# UNITED STATES PATENT AND TRADEMARK OFFICE

10/564,882

<b>Office Action Summary</b>	<b>Application No.</b> 10/564,882	<b>Applicant(s)</b> TAUTZ, HANNO	
	<b>Examiner</b> JORGE PEREIRO	<b>Art Unit</b> 4147

## **DETAILED ACTION**

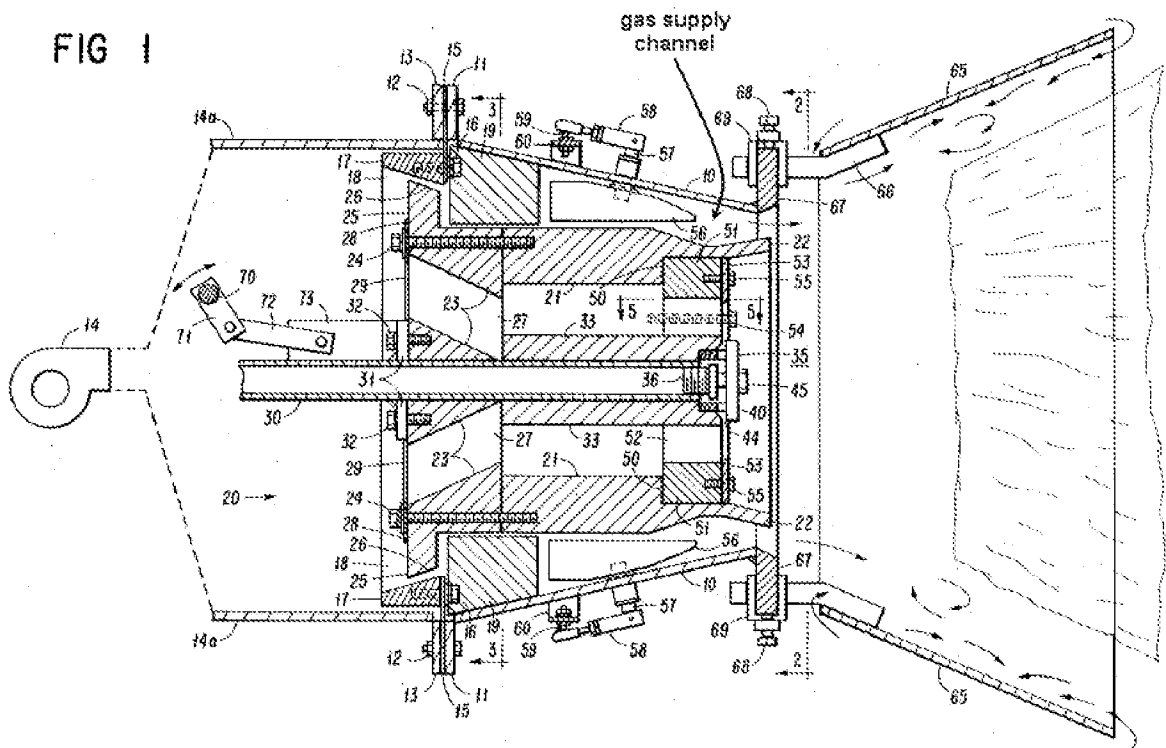
10. In re claim 1, with reference to figure 1 below, Musil discloses a burner with a burner head (see column 2, line 32) and gas supply channels (27) that are located in the burner head, characterized in that the burner head, at least in the area of the exit ends of the gas supply channels, consists of an aluminum-containing material (21) (also see column 2, lines 48-51).

11. In re claim 5, with reference to figure 1 above, Musil discloses wherein in at least one of the gas supply channels, there is a vane (56) that stabilizes the gas flow.

12. In re claim 6, with reference to figure 1 above, Musil discloses wherein the vane (56) is set back relative to the exit ends (22, 67) of the gas supply channels.

13. In re claim 7, with reference to figure 1 above, Musil discloses wherein the incline of the vane (56) is adjustable (see column 3, lines 52-68).

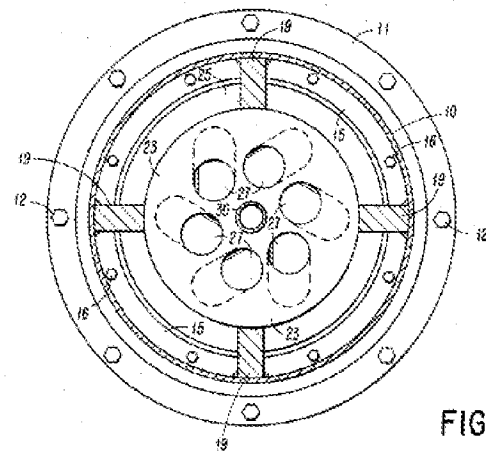
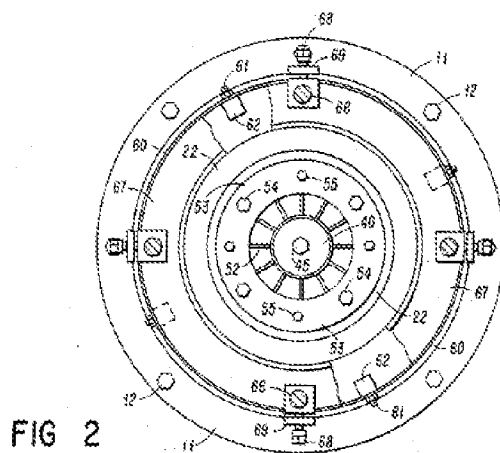
14. In re claim 8, with reference to figure 1 above and figures 2 and 3 below, Musil discloses wherein the gas supply channels (27, 30) are made from gas supply tubes that are arranged coaxially to one another.

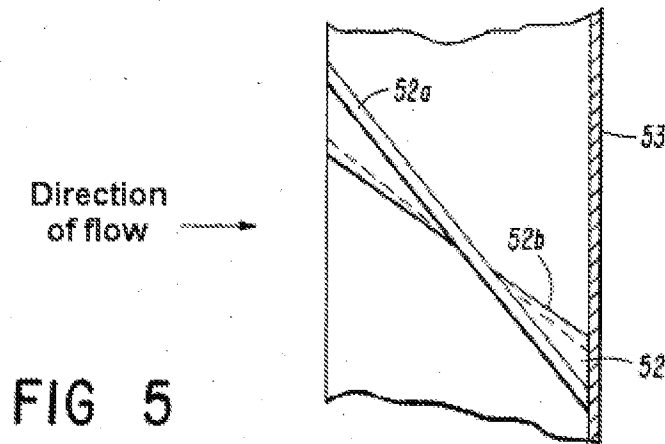
16. In re claim 10, with reference to figure 5 below, Musil discloses wherein the means (52) for producing a swirl have flow channels that are tilted tangentially against the direction of flow (see column 3, lines 25-46).

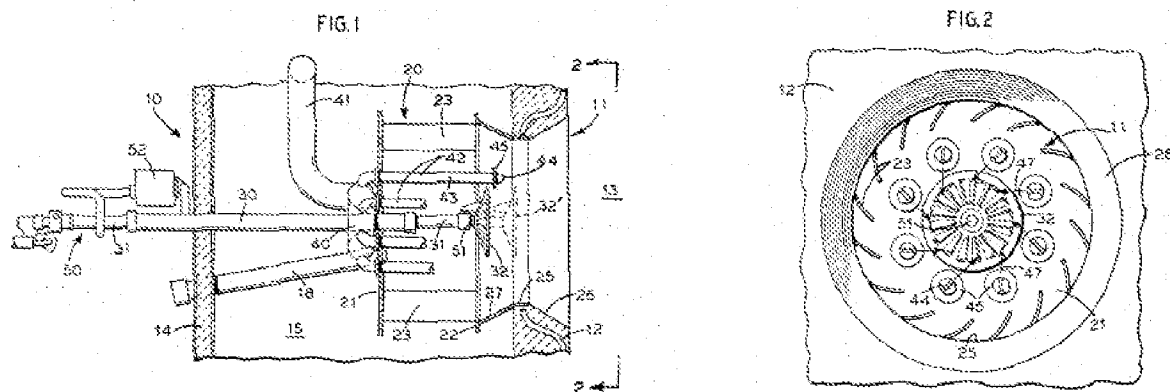
36. However, with reference to figures 1 and 2 below, Poole discloses a burner shielded against heat radiation (see column 3, lines 30-33) toward the combustion chamber side by cylindrical tubular insulation (25, 26).
